Access Compliance Report

Public Rights-of-Way

Intersection ID: 24081	Main Street: PRESCOTT_POND_LN	Cross Street: SHARPTHORNE_PL	Location: NE
ADA ID: 144ED1E96425	Ramp Type: PerpDiag	Initial Pass/Fail: Fail	Overall Compliance: No
Severity Score: 33.75			
Codes/Mitigation Info/Possible Solution		Field Measurements/Component Compliance

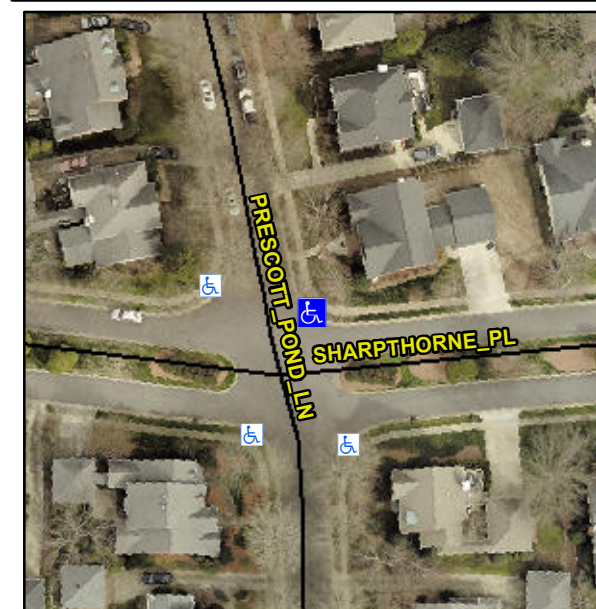
Not Found, R304.5.1, R304.2.2, R304.5.3

Compliance	Description	Data	Compliance	Description	Data
N/A	Ramp Length (in)	46.0	No	Ramp Slope (%)	11.3
No	Ramp Width (in)	47.5	No	Ramp XSlope (%)	5.7
N/A	Flare Type LT	N/A	N/A	Flare Type RT	N/A
N/A	Flare Slope LT (%)	N/A	N/A	Flare Slope RT (%)	N/A
N/A	Flare Traversable LT?	N/A	N/A	Flare Traversable RT?	N/A
N/A	Landing Length (in)	N/A	N/A	DWS Provided?	N/A
N/A	Landing Width (in)	N/A	N/A	DWS Contrast?	N/A
N/A	Landing Slope (%)	N/A	N/A	DWS Length (in)	N/A
N/A	Landing X Slope (%)	N/A	N/A	DWS Full Width?	N/A
N/A	Landing Curb? (Y/N)	N/A	N/A	DWS Offset (in)	N/A
N/A	Shared Landing?	N/A			
N/A	Gutter Ponding?	N/A	N/A	Gutter Slope (%)	N/A
N/A	Gutter Lip Ht (in)	N/A	N/A	Gutter X Slope (%)	N/A
N/A	Painted X Walk1?	No	N/A	Painted X Walk2?	No
	X Walk 1 Direction	To W		X Walk 2 Direction	To S
N/A	X Walk 1 Width (in)	N/A	N/A	X Walk 2 Width (in)	N/A
	X Walk 1 Slope (%)	0.5		X Walk 2 Slope (%)	4.3
	X Walk 1 X Slope (%)	5.1		X Walk 2 X Slope (%)	2.8

N/A	Ramp inside XWalk1?	N/A	N/A	Ramp inside XWalk2?	N/A
	Road Slope (%)	5.8	N/A	Clear Space?	N/A
	Road X Slope (%)	3.6	N/A	Clear Space to XWalk (in)	N/A
N/A	Any Obstructions?	N/A	N/A	Storm Grate/Utility Hazard?	N/A
	Obstruction Type			Storm Grate/Utility Type	
		N/A			N/A
			Yes	Surface Condition? (G/P)	Good

Remove & Replace Curb Ramp With Two New Directional Ramps or Equivalent.
